Roller radius correction

September, 2016

Japan

Radius correction factor

example calculation

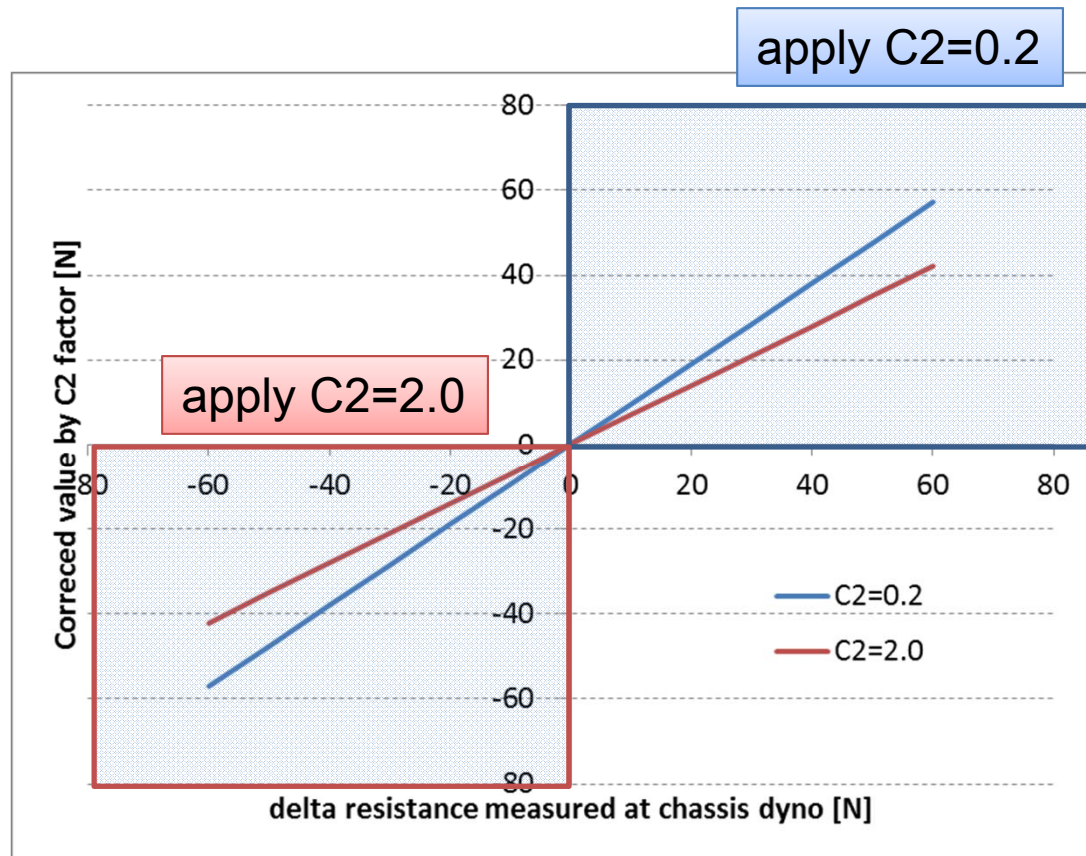
“conservative equation” will not be always conservative.

Proposal:

- If C2 was approved by authority based on the requirement of paragraph 6.6.3., the C2 should be used for delta calculation.
- If not, conservative C2 should be used which is C2=0.2 for positive side, C2=2.0 for negative side.

$$f_j = f_{j\text{Dyno}} \times \sqrt{\frac{1}{\frac{R_{\text{Wheel}}}{R_{\text{Dyno}}} \times C2 + 1}}$$

C2 shall be 0.2 except that 2.0 shall be used if the delta road load method (see paragraph 6.8. of this annex) is used and the delta road load calculated according to the paragraph 6.8.1. of this annex is negative.
